UN Regulation No. 51 (Noise of M and N categories of vehicles)

Proposal for supplement 7 to 03 series of amendments to UN Regulation No. 51

Submitted by the Informal Working Group on Measurement Uncertainties*

Figure

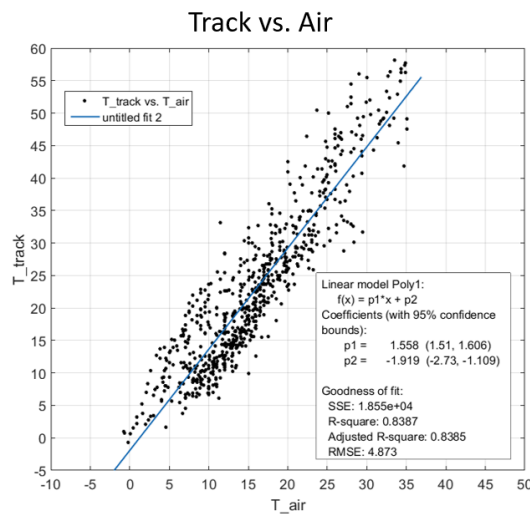
Annex 3, paragraph 2.1.3.2.2.

11. This provision clarifies the temperature range for outdoor facilities. New requirements for road surface temperature has been introduced. The maximum temperature is under discussion to be either aligned with UN Regulation No. 117 to 50°C or to be expanded for practical reasons to 60°C. There is evidence that 60 °C surface temperature correlates for with the actual mandated 40°C air temperature.
12. The tyre rolling sound component will be corrected to a reference temperature (pending work package). Thus, the temperature range is less critical as today.

Measurements of air and track surface temperature (about 700 measurement points under various ambient conditions (summer, winter, cloudy, sunny, etc...))

$$T_{Track} = 1.558 * T_{air} - 1.919$$

2.1.3.2.2. Temperature

The measurements shall be made when the ambient air temperature is within the range from 5°C to 40°C and the test surface temperature within the range from 5°C to 60°C .
